Changes to proposed District Map Amendment G-956

A revised version of DMA G-956, dated December 18, 2013, has been posted on the Planning Department website for review. It contains all of the proposed and approved changes that have occurred since October 11, 2013. The following document illustrates all of the changes to DMA G-956.

Changes made to DMA G-956 are organized into four sections, each section describing a different type of revision.

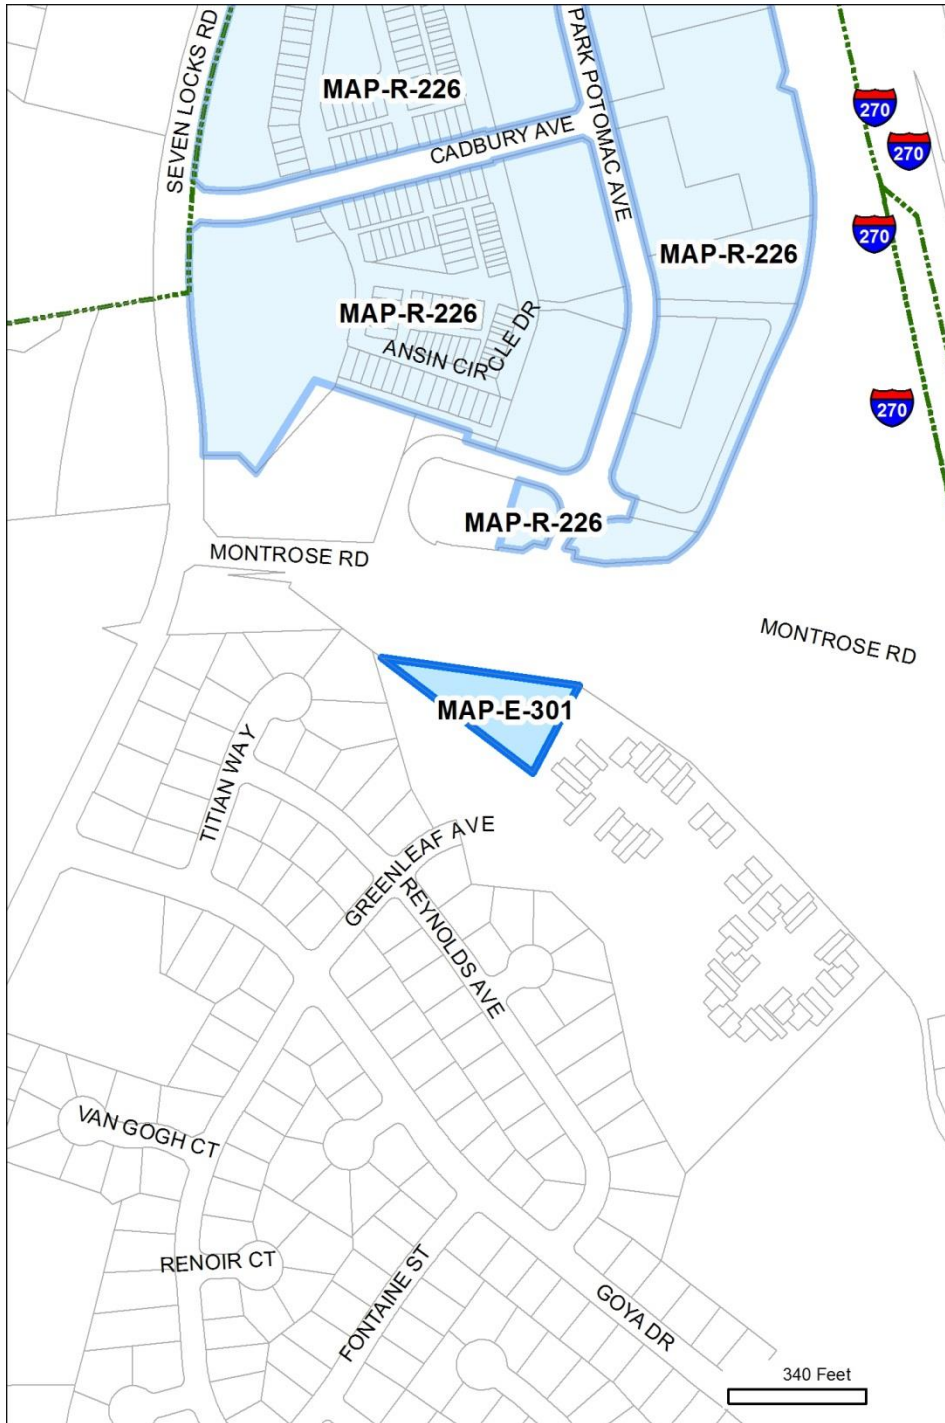
Unique ID: MAP-E-301		staff error
Master Plan ID: POTMC-10		
Master Plan:	Potomac Subregion	
Location:	Park Potomac	
Existing Zone:	I-3	
Proposed Conv: (10/11)	EOF-0.75 R-100	
Prop. Revised Conv:	CRT-1.25 C-0.5 R-0.75 H-100 T	
Category:	Owner request to match approvals	
Modifications	Zone Group:	Changed to CRT
	Overall FAR:	Increased to 1.25
	Comm'l FAR:	-
	Resid'l FAR:	-
	Height:	No change
Reason for change:		
<p><i>This portion of the Park Potomac site should have been included in the last round of revisions to the DMA under revision MAP-R-226. Staff inadvertently left this portion of the site with the formerly proposed conversion.</i></p>		
<p>MAP-R-226</p> <p><i>This site was approved under the Optional Method for the I-3 zone, and its existing approvals allow for up to 0.39 FAR of nonresidential development and up to 600 units of residential.</i></p> <p><i>The Master Plan also recommends this site as a mixed use site, suitable for the MXP zone. While the developers decided to use the I-3 optional method instead, the CRT zone is a much better fit for this site than the EOF zone.</i></p> <p><i>In terms of densities, the most appropriate translation of the site's existing approvals is to CRT-1.25 C-0.5 R-0.75 H-100 T.</i></p>

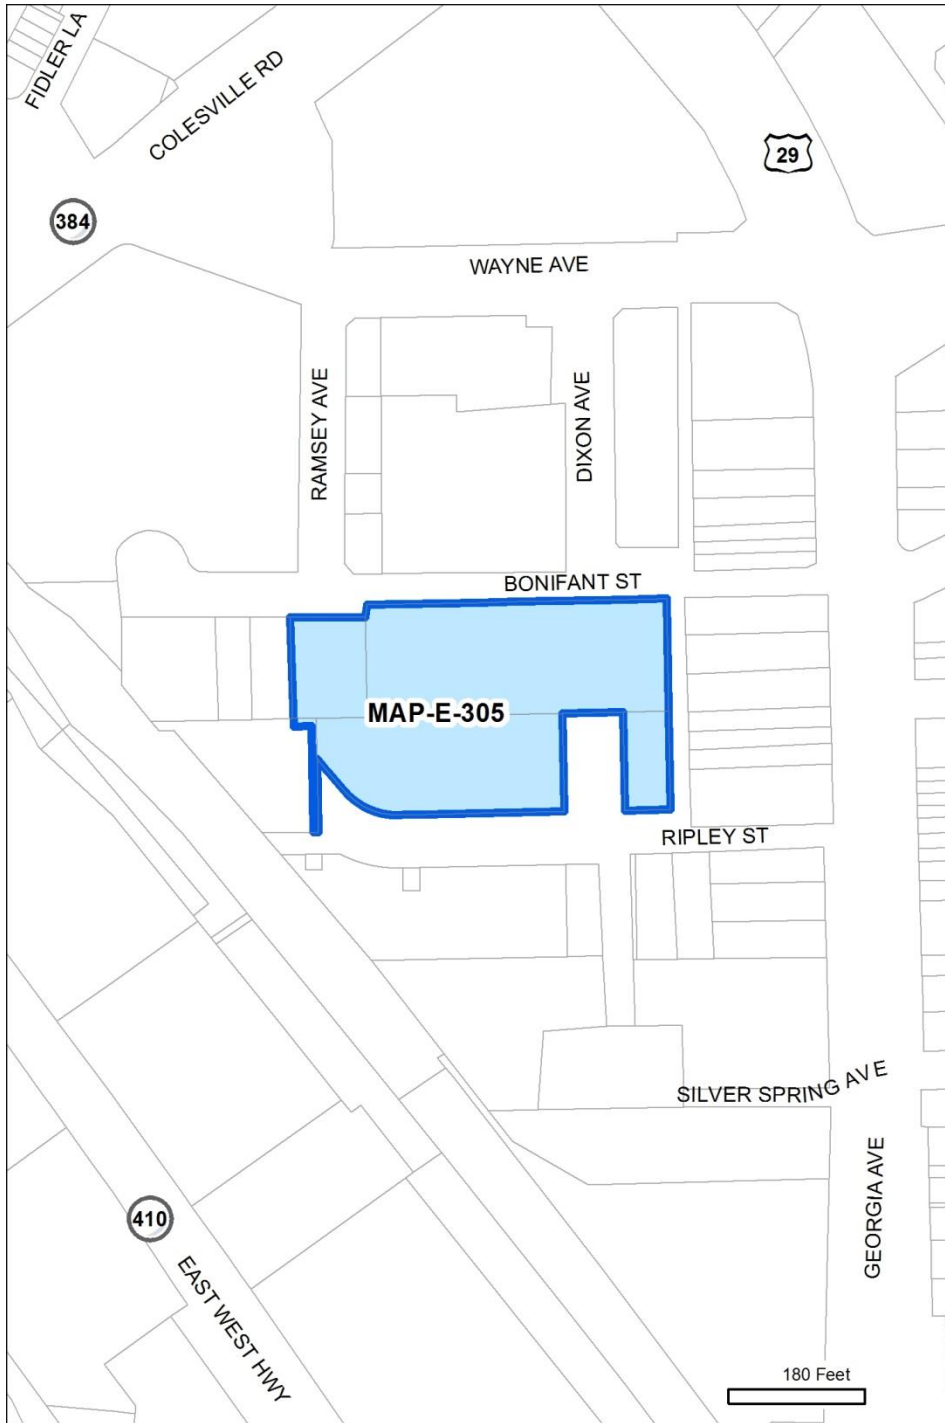
Unique ID: MAP-E-305		staff error
Master Plan ID: SLVSP-14B		
Master Plan:	Silver Spring CBD	
Location:	Bonifant and Dixon	
Existing Zone:	CBD-2	
Proposed Conv: (10/11)	CR-5.0 C-2.0 R-5.0 H-200 T	
Prop. Revised Conv:	CR-5.0 C-4.0 R-5.0 H-200 T	
Category:	Error	
Modifications	Zone Group:	No change
	Overall FAR:	No change
	Comm'l FAR:	Increased to 4.0
	Resid'l FAR:	No change
	Height:	No change
Reason for change:		
<p><i>This property was recommended to be limited to 2.0 FAR of non-residential development in the 1993 Master Plan, however, the 2000 Master Plan did not retain that limitation.</i></p>

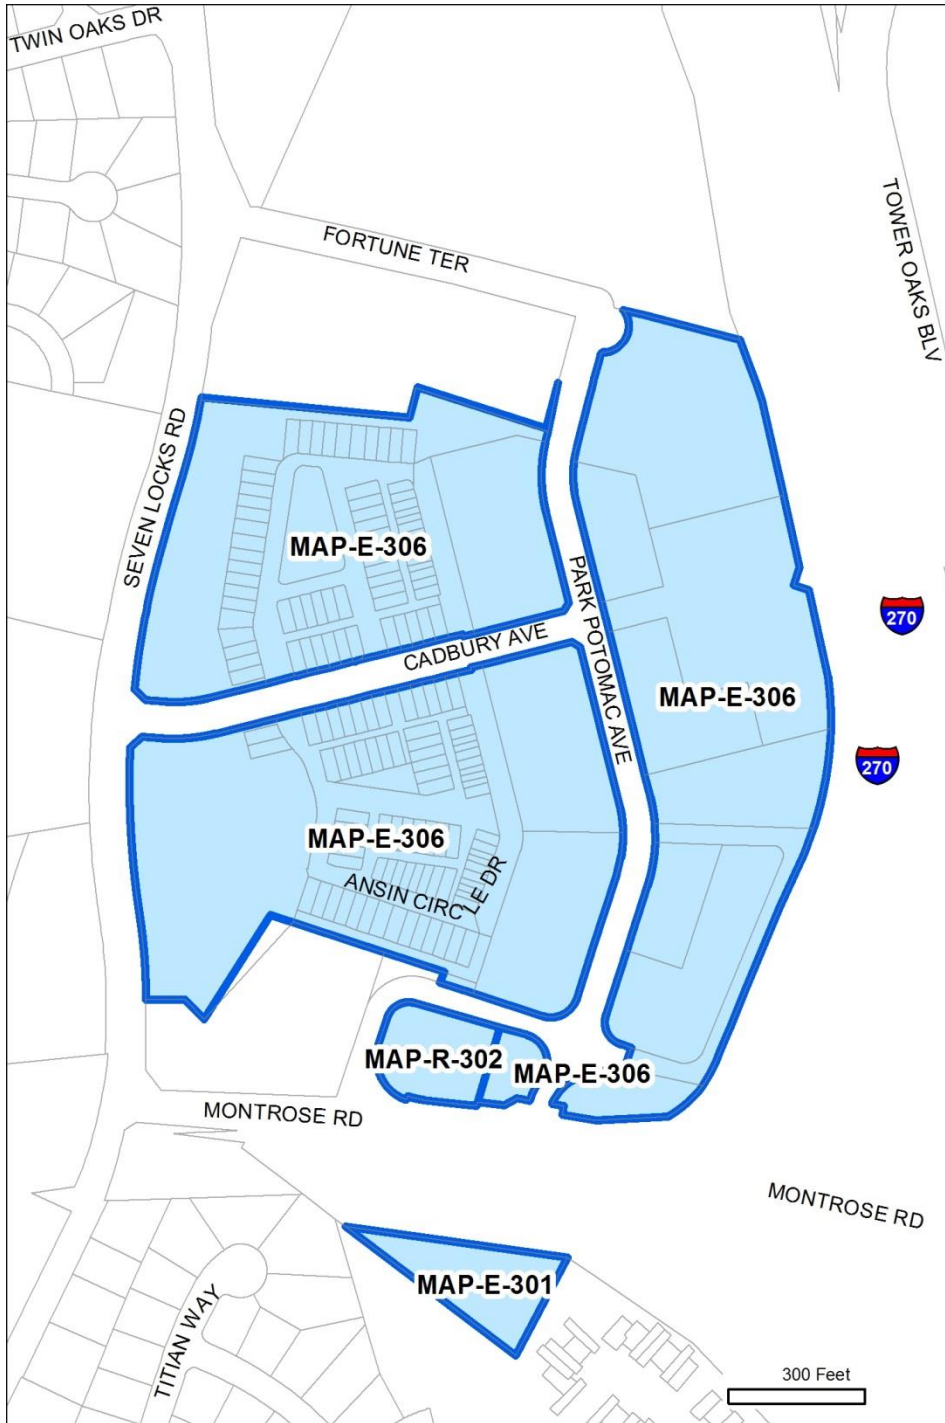
Unique ID: MAP-E-306		staff error
Master Plan ID: POTMC-10		
Master Plan:	Potomac Subregion	
Location:	Park Potomac	
Existing Zone:	I-3	
Proposed Conv: (10/11)	CRT-1.5 C-0.5 R-0.75 H-100 T	
Prop. Revised Conv:	CRT-1.25 C-0.5 R-0.75 H-100 T	
Category:	Error	
Modifications	Zone Group:	No change
	Overall FAR:	Reduced to 1.25
	Comm'l FAR:	No change
	Resid'l FAR:	No change
	Height:	No change
Reason for change:		
<p>When changing the DMA to reflect the owner request to match development approvals in MAP-R-226, the overall FAR was shown as 1.5.</p> <p>However, with the commercial component limited to 0.5 and the residential component limited to 0.75, there was no way for development to exceed 1.25 FAR.</p> <p>For that reason, the overall FAR of 1.5 was made in error, and should be reduced to 1.25.</p>

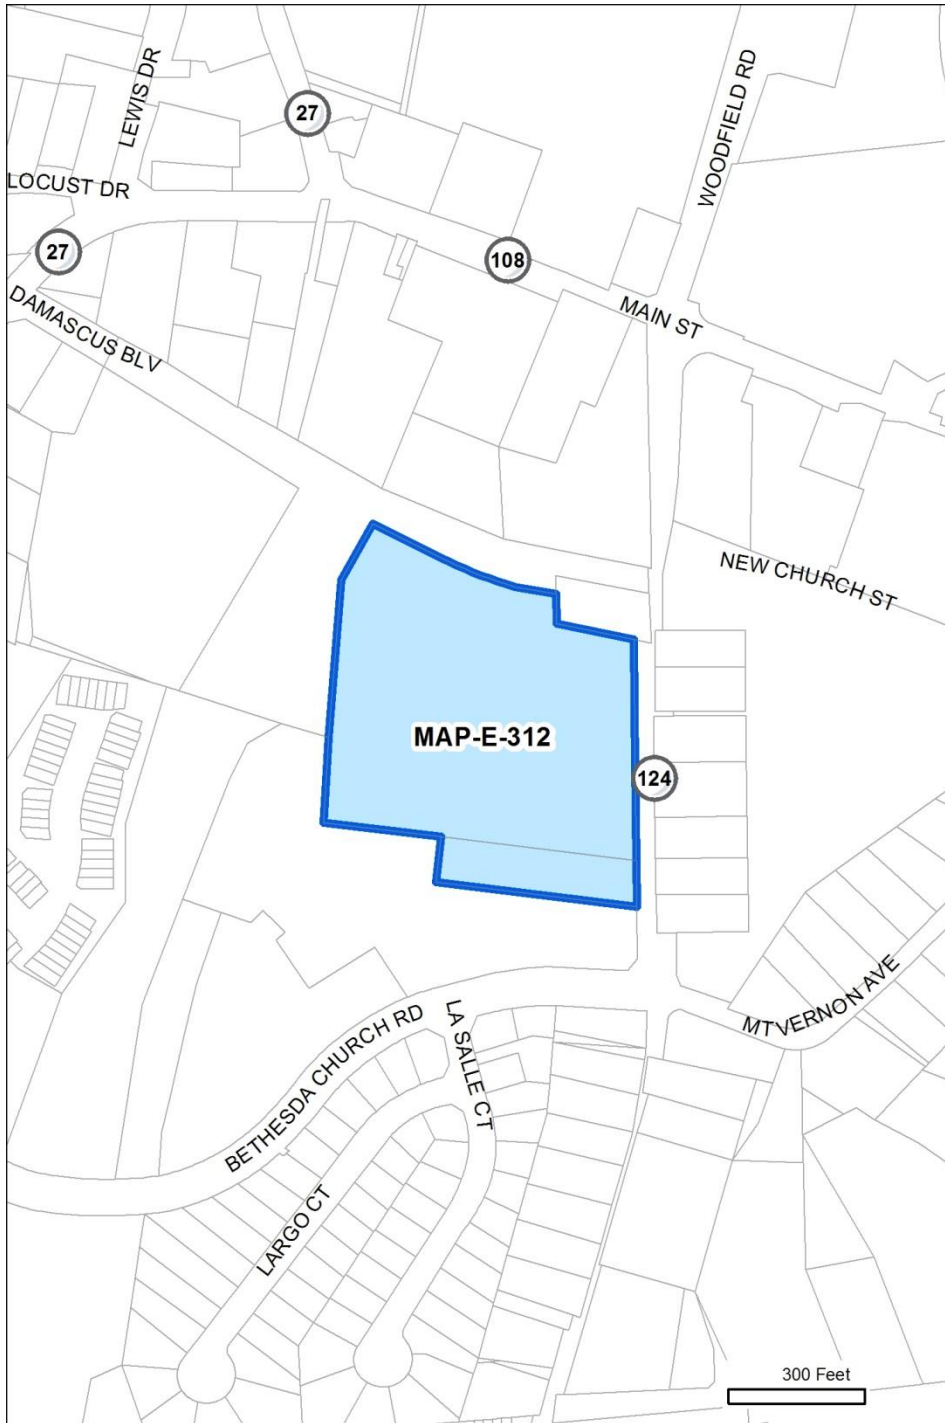
Unique ID: MAP-E-312		staff error
Master Plan ID: DAMSC-05		
Master Plan:	Damascus	
Location:	Damascus Blv & Woodfield Rd	
Existing Zone:	MXTC/TDR	
Proposed Conv: (10/11)	CRT-1.5 C-1.0 R-0.5 H-55 T	
Prop. Revised Conv:	CRT-1.0 C-0.5 R-0.5 H-55 T	
Category:	Error	
Modifications	Zone Group:	No change
	Overall FAR:	Reduced to 1.0
	Comm'l FAR:	Reduced to 0.5
	Resid'l FAR:	No change
	Height:	No change
Reason for change:		
<p><i>The Damascus Master Plan calls for limiting commercial development to 0.5 FAR in the "outer area."</i></p> <p><i>Staff erroneously granted the 1.0 commercial FAR that the plan calls for in the "inner area".</i></p> <p><i>However, the plan makes it clear that this particular parcel, despite being fairly close to the town center is actually considered a part of the "outer area" and therefore should be limited to 0.5 FAR of commercial.</i></p>

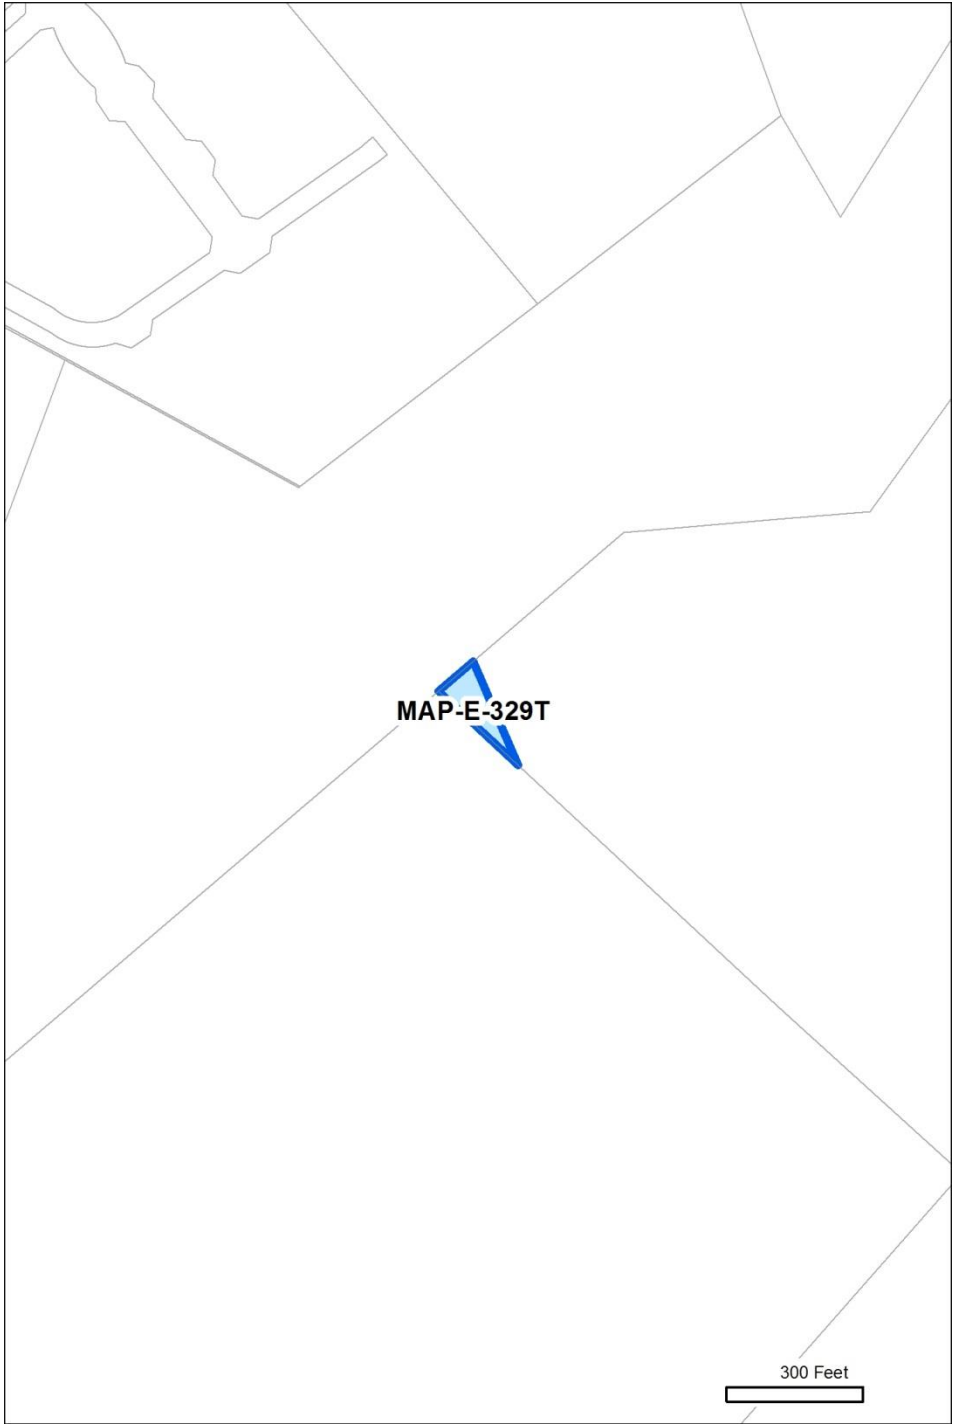
Unique ID: MAP-E-329T		staff error
Master Plan ID: CLRKG-05		
Master Plan:	Clarksburg	
Location:	Cabin Branch	
Existing Zone:	RMX-1/TDR	
Proposed Conv: (10/11)	<null>	
Prop. Revised Conv:	TDR-7.0	
Category:	Error	
Modifications	Zone Group:	-
	Overall FAR:	-
	Comm'l FAR:	-
	Resid'l FAR:	-
	Height:	-
Reason for change:		
<p><i>This sliver of land is currently in the RMX-1/TDR zone, however, it was inadvertently omitted from the new TDR Overlay zone.</i></p> <p><i>It should be included in the TDR Overlay.</i></p>

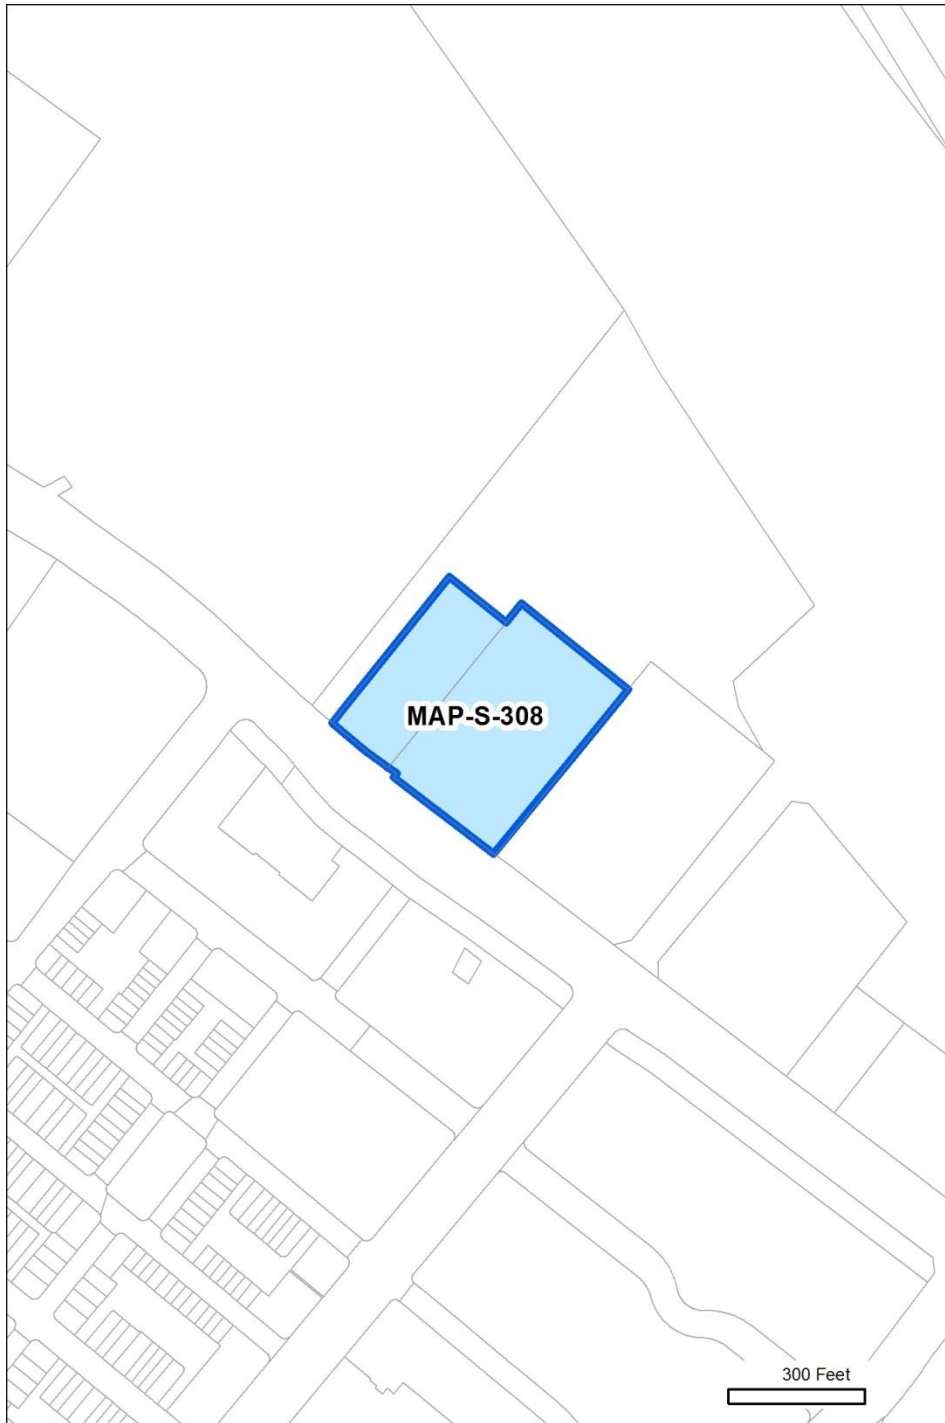
Unique ID: MAP-S-308		staff recommendation
Master Plan ID: SDYGR-10		
Master Plan:		Shady Grove
Location:		
Existing Zone:		TOMX-2
Proposed Conv: (10/11)		GR-0.75 H-50 T
Prop. Revised Conv:		CRT-0.75 C-0.75 R-0.25 H-50 T
Category:		Staff Recommendation
Modifications	Zone Group:	Changed to CRT
	Overall FAR:	No change
	Comm'l FAR:	-
	Resid'l FAR:	-
	Height:	No change
Reason for change:		
<p><i>This area is zoned TOMX-2.</i></p> <p><i>The Shady Grove Sector Plan recommends that the area is not appropriate for residential development.</i></p> <p><i>The original draft DMA proposed converting this area to GR.</i></p> <p><i>However, because both GR and CRT both allow residential development, and CRT is more compatible with the uses permitted in TOMX-2, staff feels it is better to convert this property to CRT.</i></p>

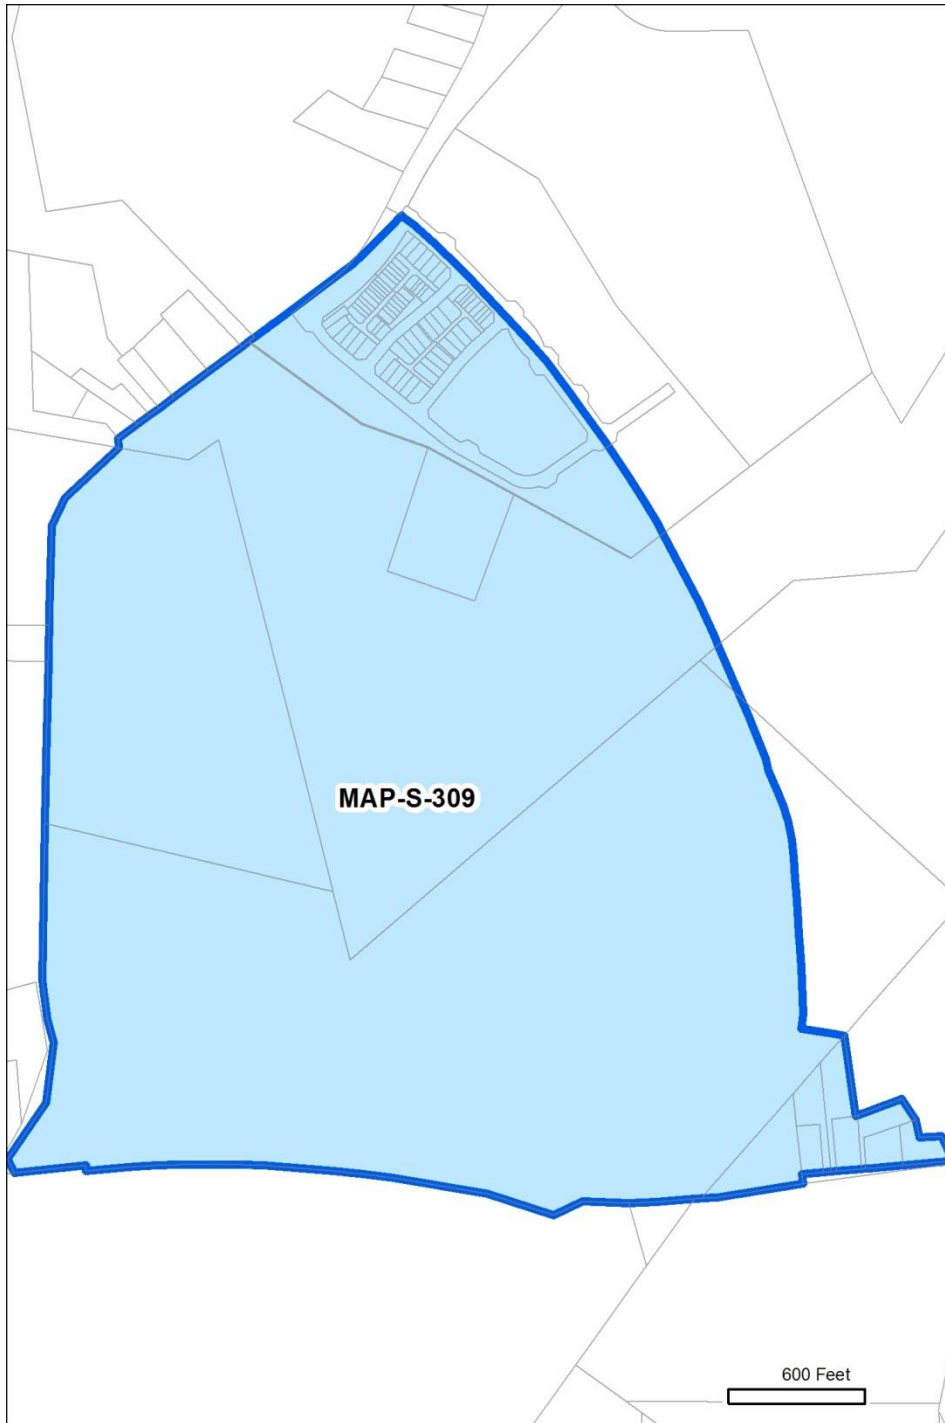
Unique ID: MAP-S-309		staff recommendation
Master Plan ID: CLRKG-05		
Master Plan:		Clarksburg
Location:		
Existing Zone:		RMX-1/TDR
Proposed Conv: (10/11)		CRT-0.75 C-0.25 R-0.5 H-65 T
Prop. Revised Conv:		CRT-0.5 C-0.25 R-0.25 H-65 T
Category:		Staff Recommendation
Modifications	Zone Group:	No change
	Overall FAR:	Reduced to 0.5
	Comm'l FAR:	No change
	Resid'l FAR:	Reduced to 0.25
	Height:	No change
Reason for change:		
<p><i>This area is currently zoned RMX-1/TDR.</i></p> <p><i>The Zoning Ordinance limits non-TDR development to 2.18 dwelling units per acre in this zone. Additional density is available only through the purchase of TDRs</i></p> <p><i>The Clarksburg Master Plan recommends a maximum density of 1,950 dwelling units (7.5 dwelling units per acre) only through the purchase of TDRs.</i></p> <p><i>Staff is proposing changes to the TDR Overlay in terms of how it interfaces with mixed-use zones. This change requires that only the base (non-TDR) density be mapped.</i></p> <p><i>The full density will still be achievable because the TDR Overlay sits on top of the CRT zone and will allow the density as specified in the Sector Plan.</i></p> <p><i>In this case, the base density of 2.18 dwelling units per acre will fall between 0.07 and 0.12 FAR, depending on the mix of unit types.</i></p> <p><i>Therefore, the residential FAR should be reduced.</i></p>
